SERVICE TECHNICAL INFORMATION

ONE POINT REPAIR

UTSUNOMIYA, OCTOBER 15, 1996
 REF. NO. : SI-96-033
 CUSTOMER RELATIONS & SERVICE DIV.

MODEL : LCX-700M, XR-M7
 SUBJECT : Does not initialize after power is turned on.
 SYMPTOM : When the set fails to initialize after the power is turned on (Direct Key LED blinks), perform the remedy described below.

Mechanism
 Right side view

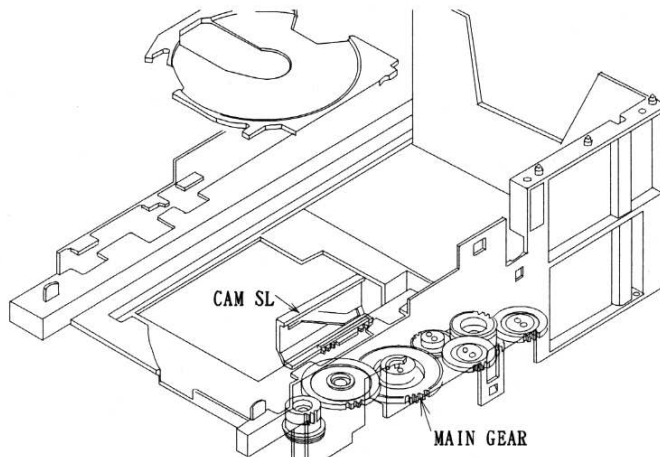
REMEDY : Check the number of main gear teeth while a CD is being chucked (See Fig. 2). If 11 teeth are not seen, replace the CAM SL.

Replace the CAM SL.

Part No.	Part Name	Ref. No.
84-ZG2-224-110	CAM SL	—
